Engineer of Record for the Structure
Structural Systems of N. Fl, Inc.
Raul Reyes, PE 88925
1634 SE 47th Street #3
Cape Coral, FL 33904

This document has been reviewed for conformance with the design intent of the structure and specified design criteria.

BUILDER	DR Horton
PROJECT	2221 F 170 B RH
MODEL	2221
ADDRESS	--
CITY, STATE	--, FL.
LOT	--
COUNTY	--
DRAWN BY	D.W.
ENG. BY	D.W.

MODEL 2221 F
2 CAR GARAGE
14587 STILLWATER WAY
NAPLES, FLORIDA
LOT: 34 BLOCK: 7
SUBDIVISION: NAPLES III FORESTAR

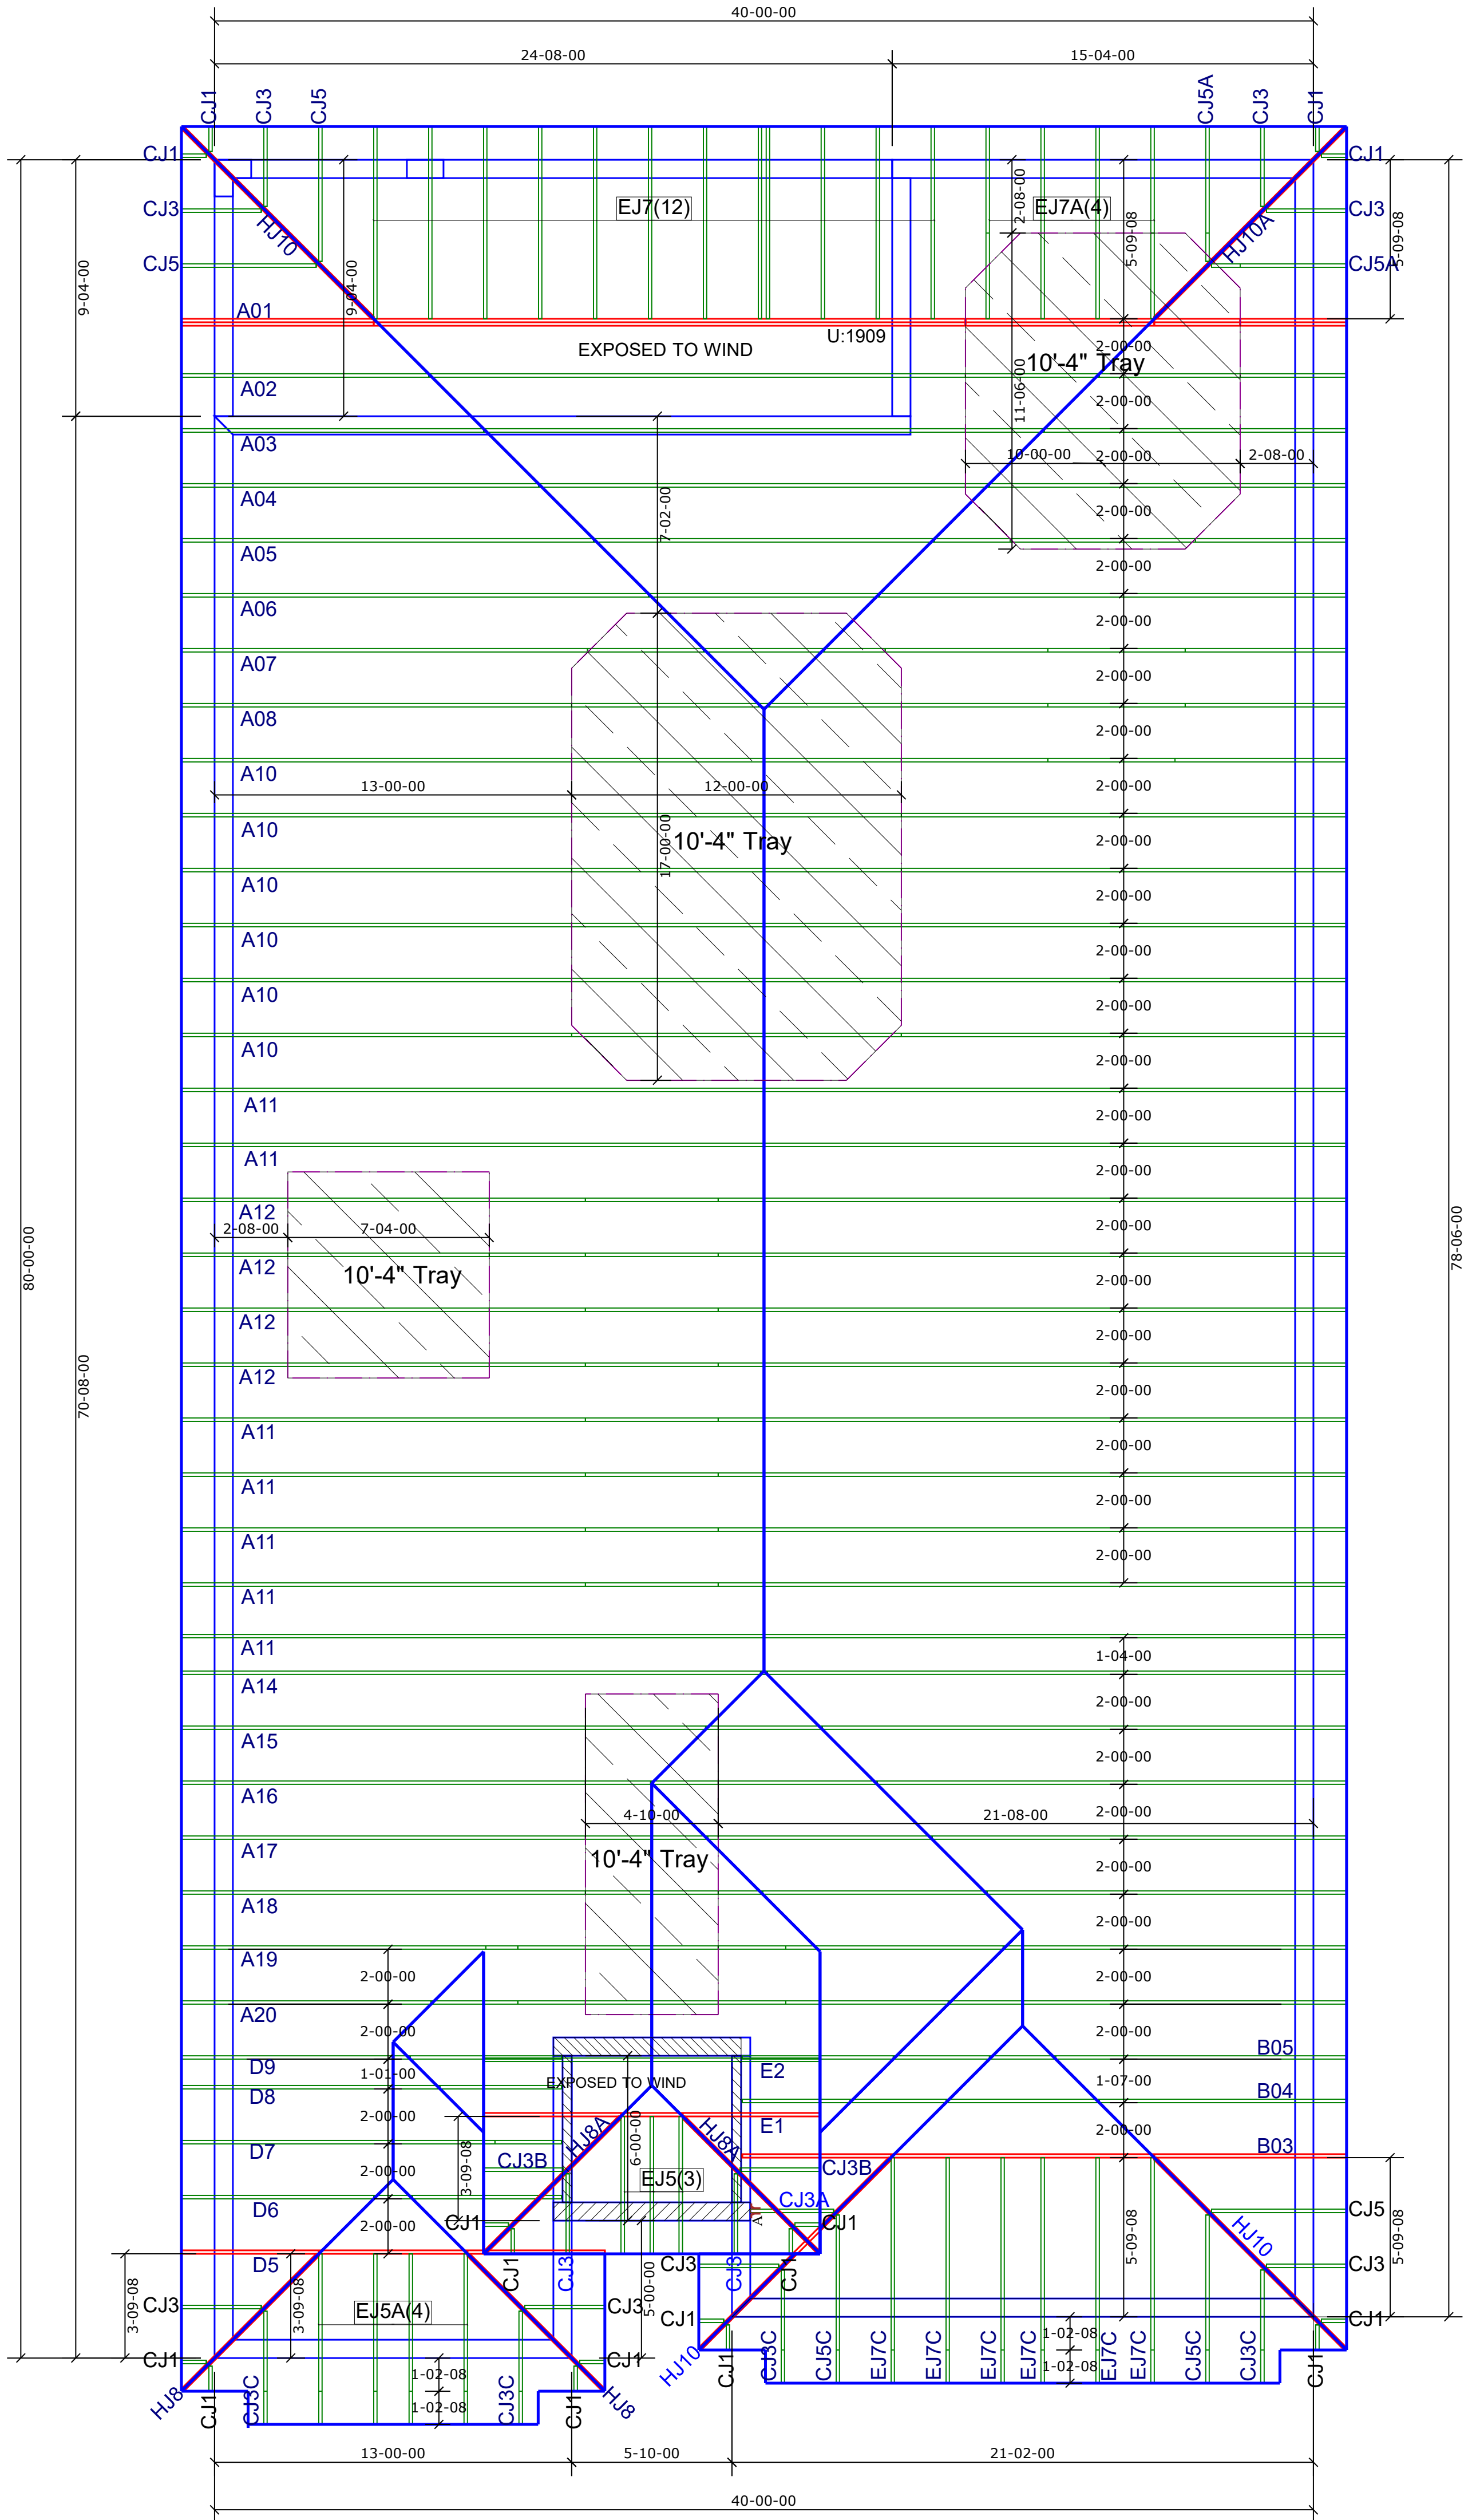
☒ Accepted As-Is ☐ Accepted As Noted ☐ Revise and Resubmit
